**ROAD LAYOUT  
HOUSING DEVELOPMENT  
FROGSTON ROAD (POD C)  
EDINBURGH**

STAGE 3 ROAD SAFETY AUDIT  
(SPA Ref No: 4282)

Roads Authority: The City of Edinburgh Council

Client: Barratt Homes

## Annex 2 PROBLEM LOCATION PLAN

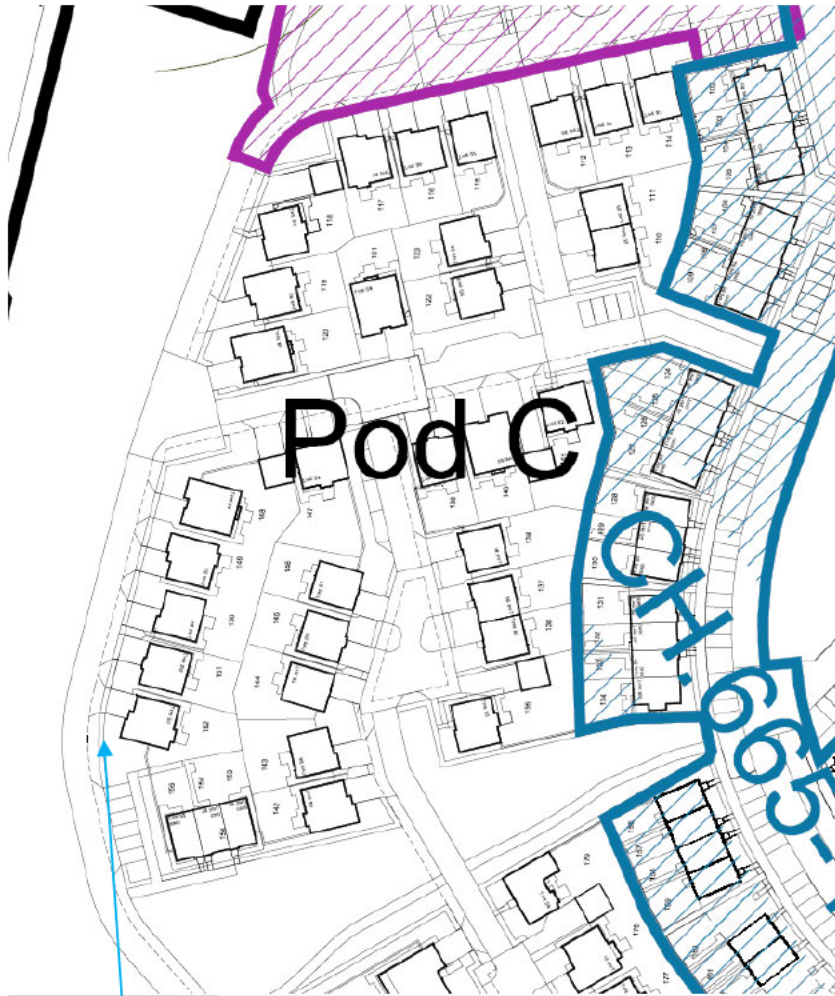
#### 4.5.1 PROBLEM

Location: Dunnikier Way at Plot  
Drawing(s): E9876~0925

Summary: A lack of street lighting can increase the potential for road users to miss obstructions or level differences in the surface.

At plot 152 it was noted that the lighting column had a 'dark' head.

It is recommended that the lighting head be examined and repaired as soon as possible.
